From: [Mellissa Parsons](#)
To: [Chris Dimis](#)
Cc: [Andrew Collyer](#); [Daniel Ogden](#)
Subject: 70 The Strand | Kitchen Drawing RFI"s
Date: Friday, 14 May 2021 1:01:37 PM
Attachments: [facebook_logo@2x_26508827-e760-4f91-af51-7276851ce991.png](#)
[instagram_logo@2x_af1f28be-4495-436e-9a55-2af51774bcdd.png](#)
[linkedin_logo@2x_a7c89ab1-b2a6-4030-99d3-0f09422a2e81.png](#)
[RCQlogo_d039a935-3f1d-4532-80a4-3227b78e5fd9.png](#)

3DA		PROJECT: 70 THE STRAND		CAFE/BAR INTERNAL ELEVATIONS			
Drafting, Visualization, and Animation				DATE: MAR 2021	SCALE: 1:200 ON A3	CB01 INT2 rev8	
13 Godwin St Bexley NSW 2207		Telephone: + 61 2 9556 1430 Facsimile: + 61 2 8207 8988 Email: info@3da.net.au		DRAWN: AG	PRO NO. 2020 03	REVISION:	SHEET:

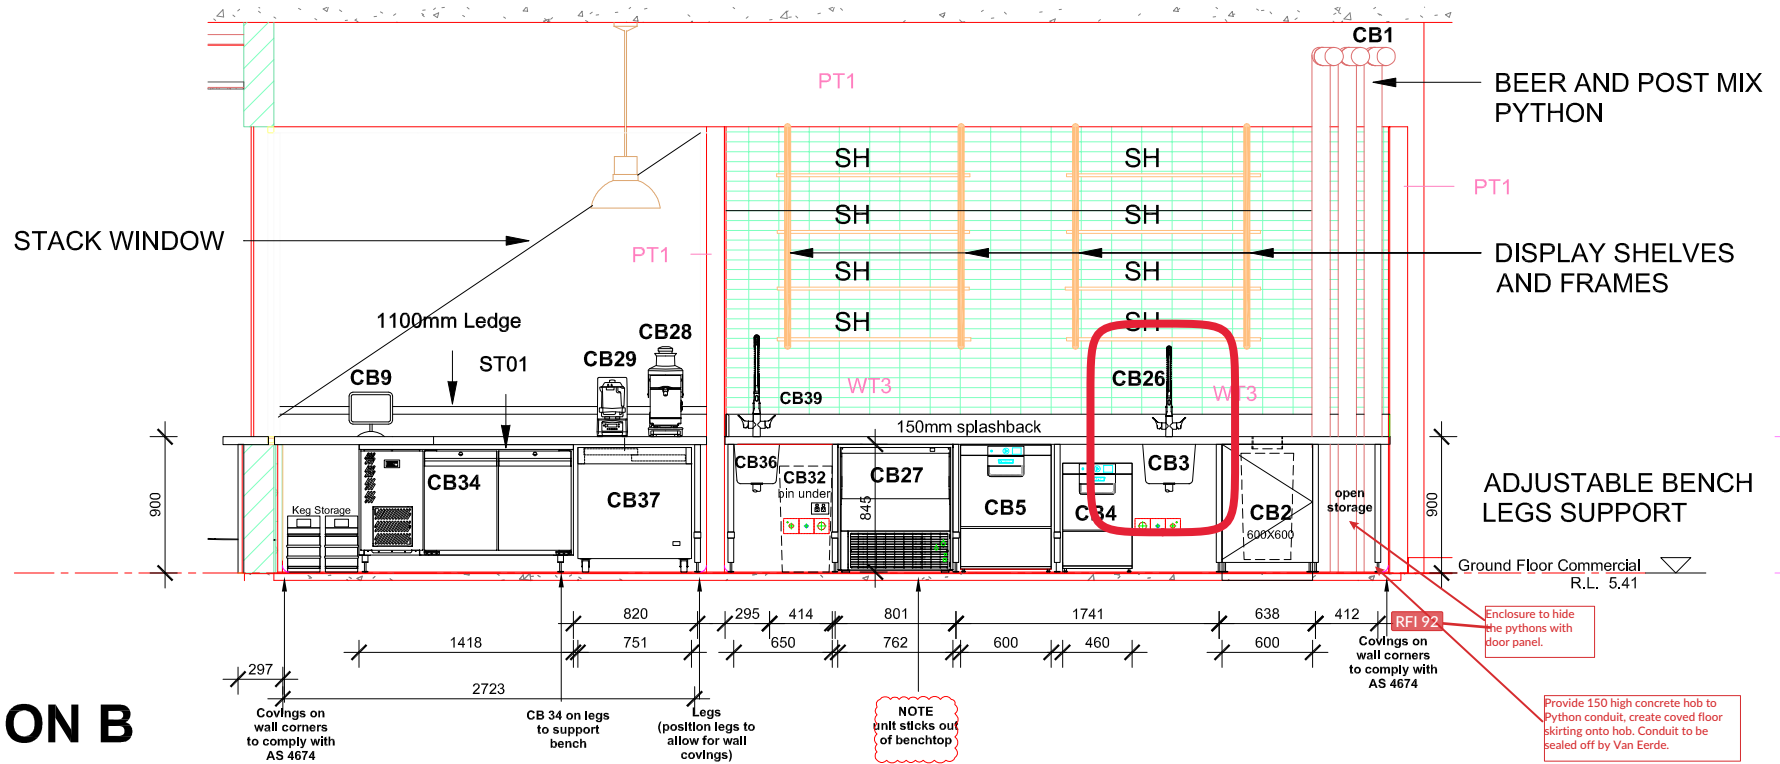
Schedule CB3 is a sink and CB26 is a tap
CB01 INT1 Rev 8 – they match the schedule
CB01 INT3 Rev 8 - they are reverses, so tap is CB3 and sink CB26
CB01 INT2 Rev 8 - match the schedule CB3 sink and CB26 tap

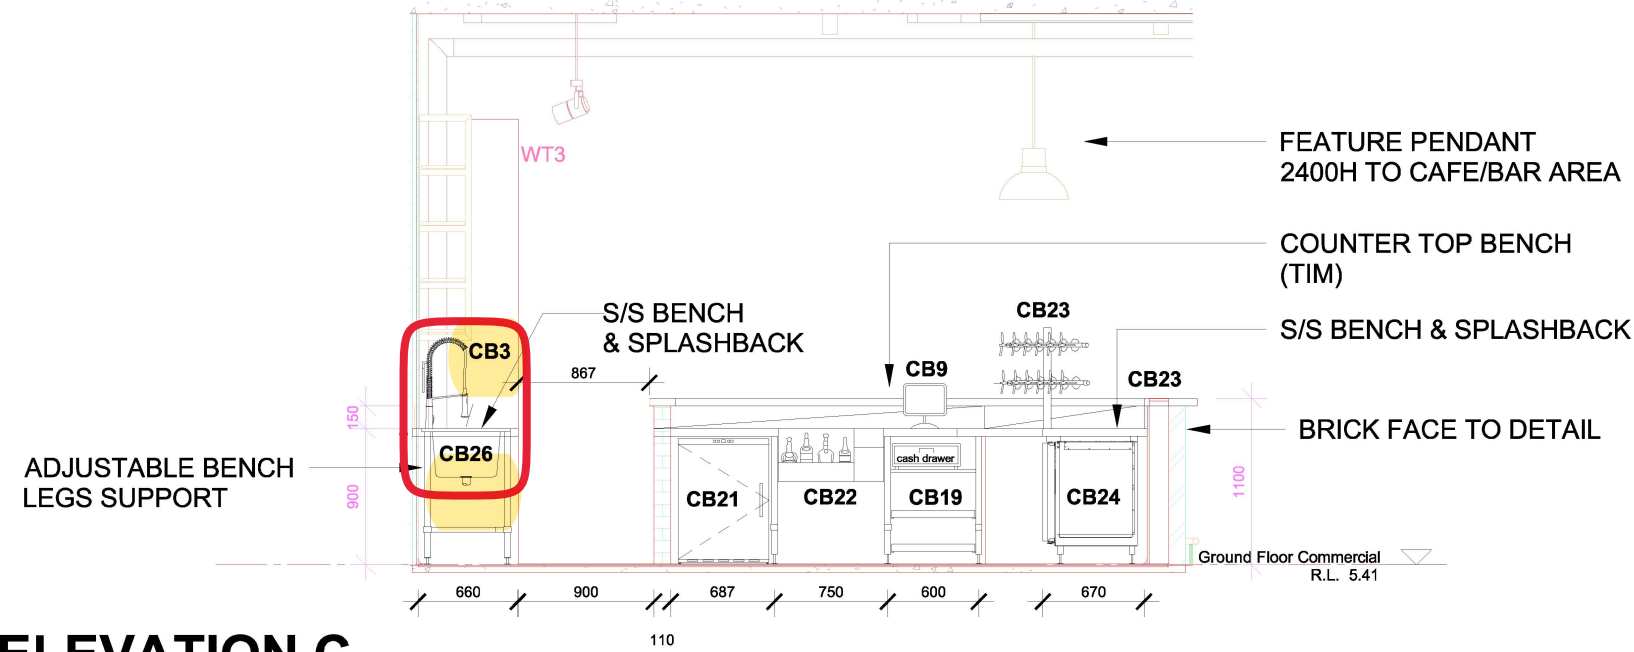
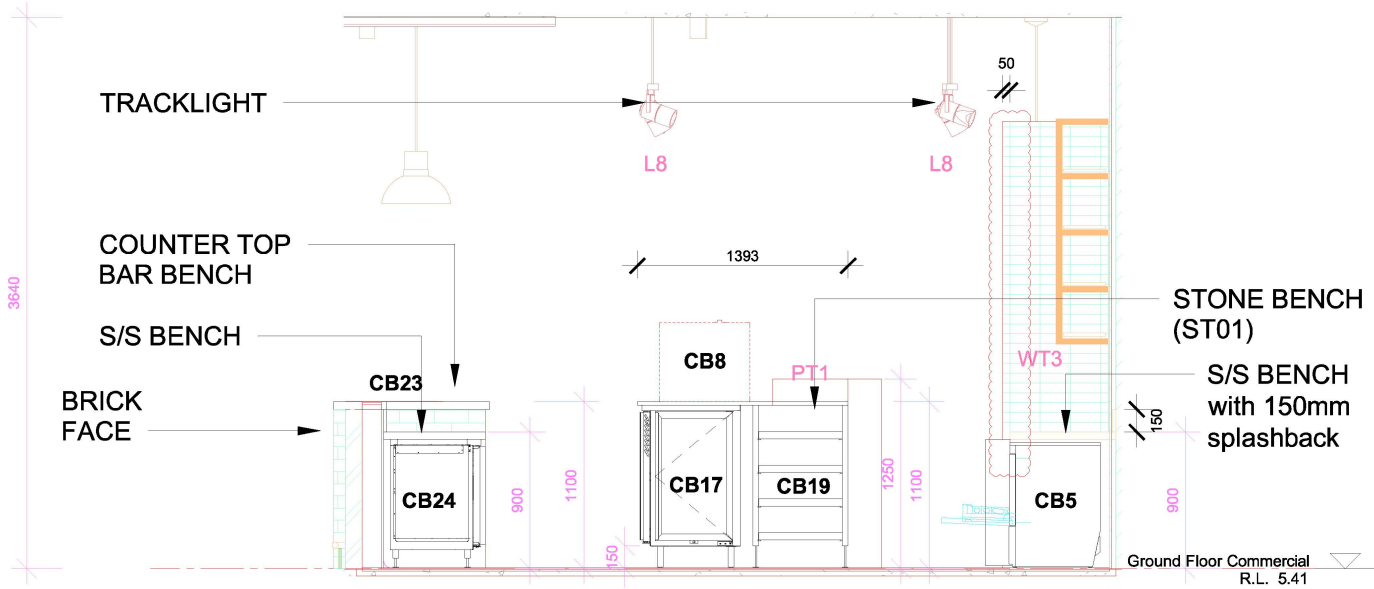
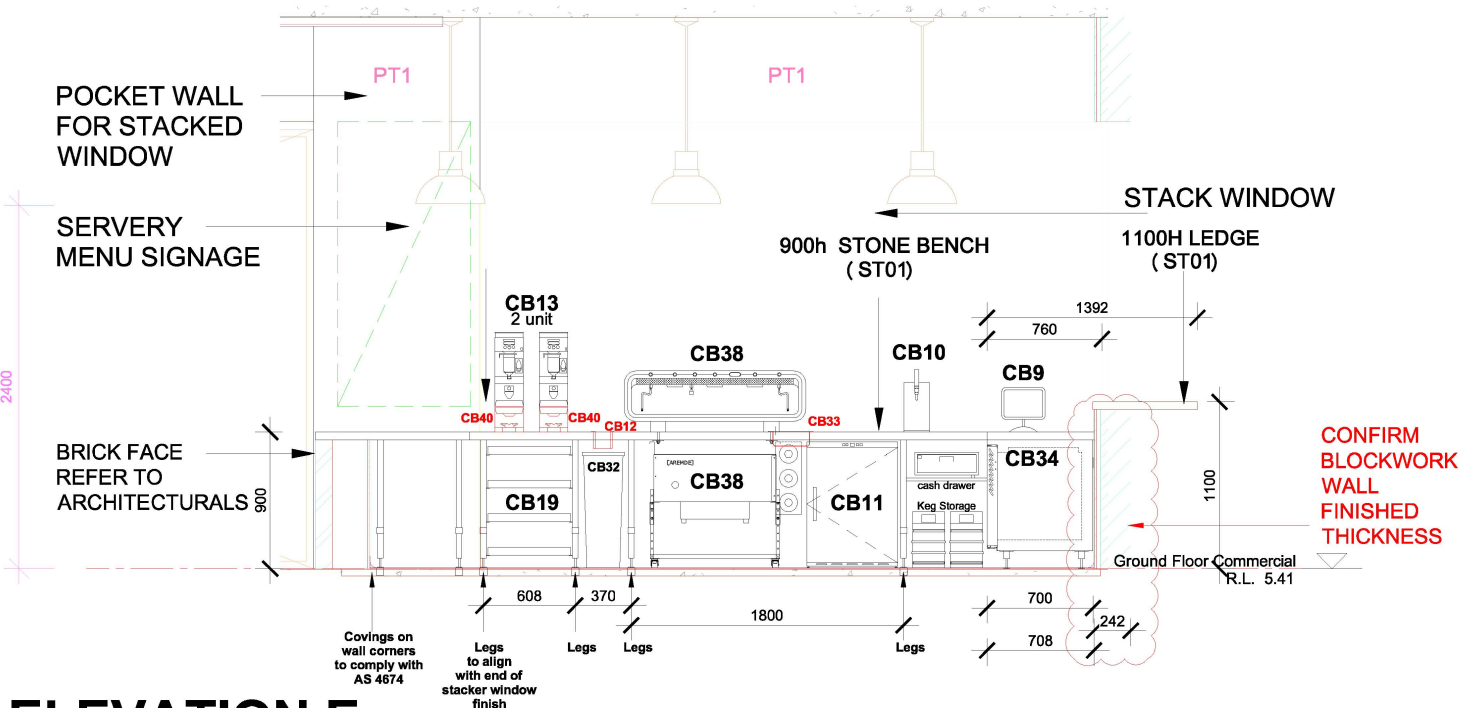
CB3 (sink) & CB26 (tap) are not that clear

Can you please confirm which way it is and update the incorrect drawings and send back to me ASAP

Great pickup on the details. Alex has updated the drawing and changed over the labels, please find attached.
